Model: Bellini – Punch Unit		Date: 17-Oct-00	No.: MA812001
Modified Article: Punch Drive Board		Prepared by: S. Hizen	
From: Technical Services Dept., GTS Division			
Reason for Modification:	<input type="checkbox"/> Parts catalog correction <input type="checkbox"/> To facilitate assembly <input type="checkbox"/> Part standardization	<input type="checkbox"/> Vendor change <input type="checkbox"/> To improve reliability <input checked="" type="checkbox"/> Other	<input type="checkbox"/> To meet standards ()

Model: Bellini – Punch Unit

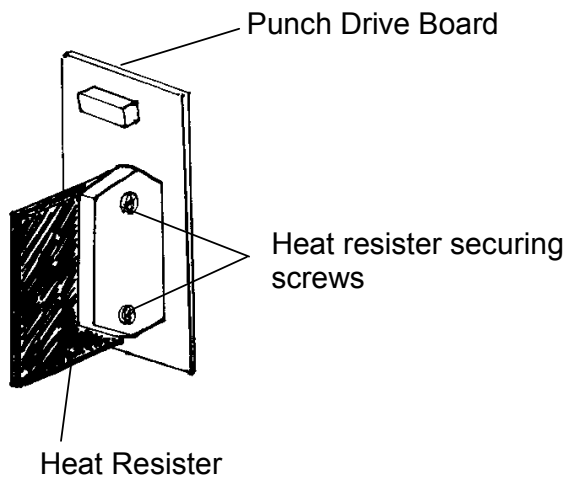
The heat resister securing screws of the Punch Drive Board have been locked in place with an adhesive.

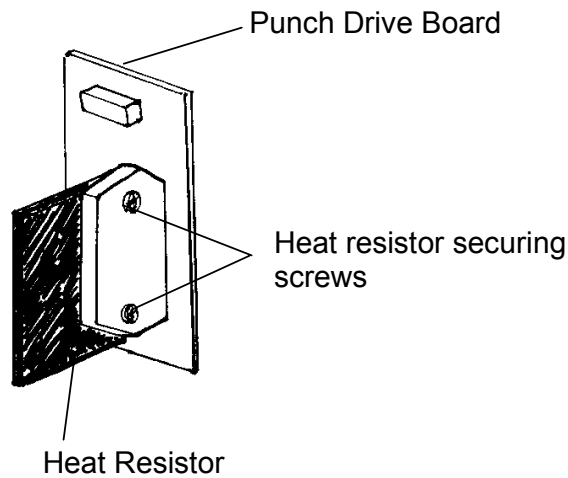
To improve the reliability of the heat resistor securing screw lock, the punch drive board unit has been modified.
